Economic Commission for Europe**Inland Transport Committee****World Forum for Harmonization of Vehicle Regulations****Working Party on Noise****Seventieth session**

Other business**Proposal for a Supplement to UN Regulation No. 28 (Audible warning devices)****Submitted by the experts from France***

Simplified drawing of an assembled electronic warning device

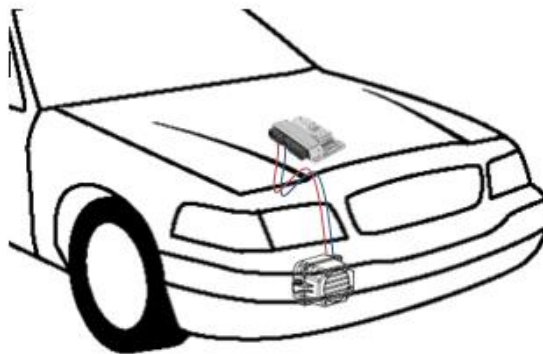
1. This proposal aims to take into account new technologies that permit to emit an acoustic signal which is intended to give audible warning of the presence of a vehicle in a dangerous road traffic situation and which is intentionally operated by the driver.

2. It is the case especially for piezo-electric devices, such as a loudspeaker that could emit an acoustic signal.

2.4.5. **"Electronic" means a principle of operation by electric or electro-magnetic force with amplifier and speaker or resonator;**
